**TECHNICAL EVALUATION REPORT
DRESDEN STATION UNITS 2 AND 3
STATION BLACKOUT EVALUATION**

Science Applications International Corporation
An Employee-Owned Company

Figure 1: Dresden Electrical One Line Diagram With AAC

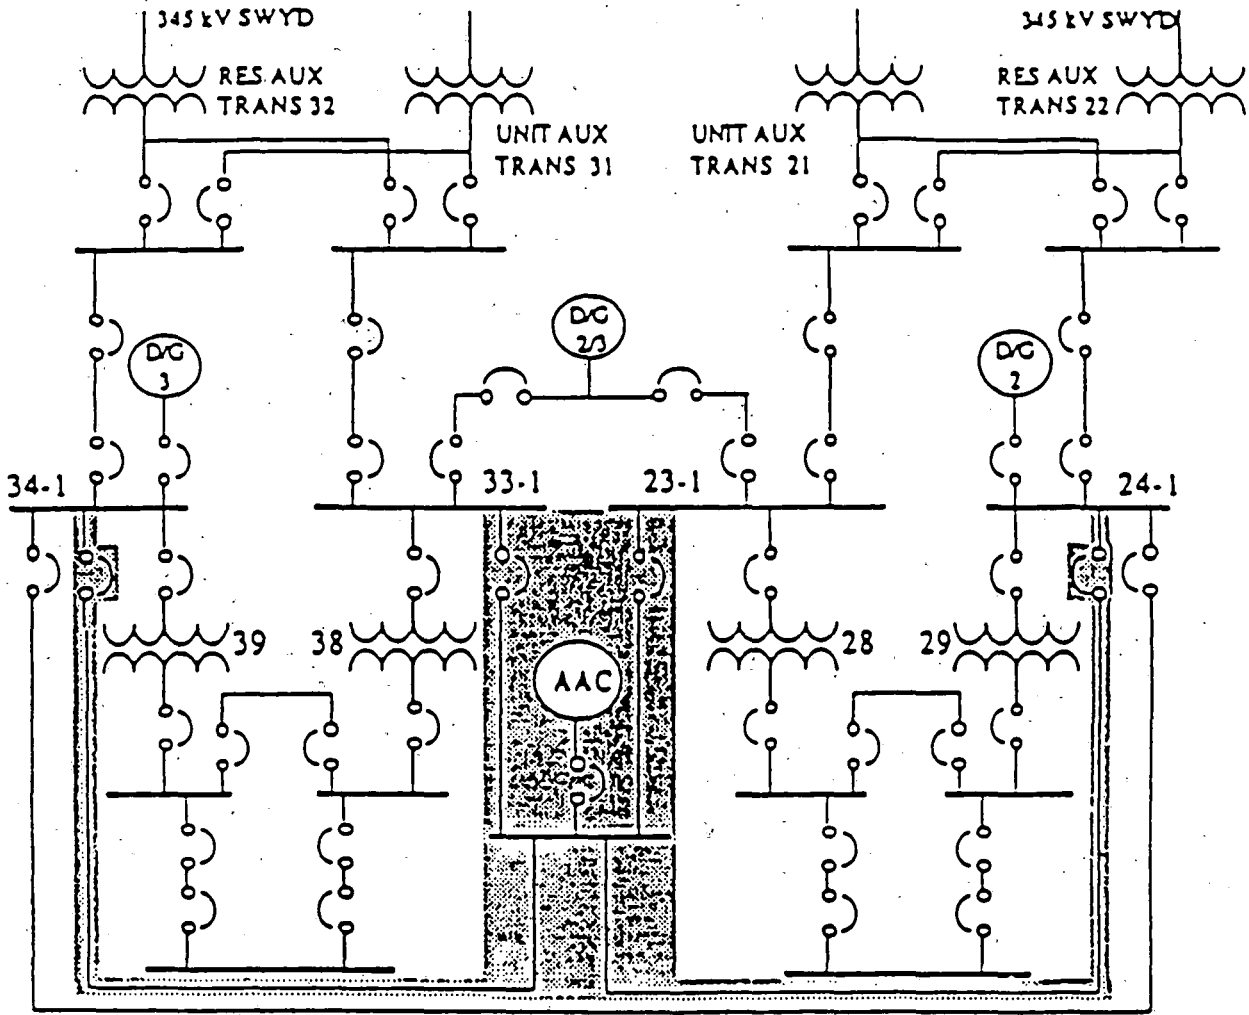
available within one hour. With a capacity of 5700 kW, the proposed AAC power source would produce twice the power of an EDG, hence it would be capable of powering one safety train of each unit simultaneously. This capacity is considered adequate.

The proposed circuits for connecting the AAC power source to the safe shutdown buses may be credited as the cross-tie between safety buses 23-1 and 33-1. However, all of the connections from safety buses 23-1, 24-1, 33-1, and 34-1 to the AAC power source output circuit breaker would have to be safety grade since all these circuits are directly connected to the AAC power source output breaker.

The detailed design of the AAC power source needs to be reviewed to verify that the requirements of NUMARC 87-00 Appendix B are met.
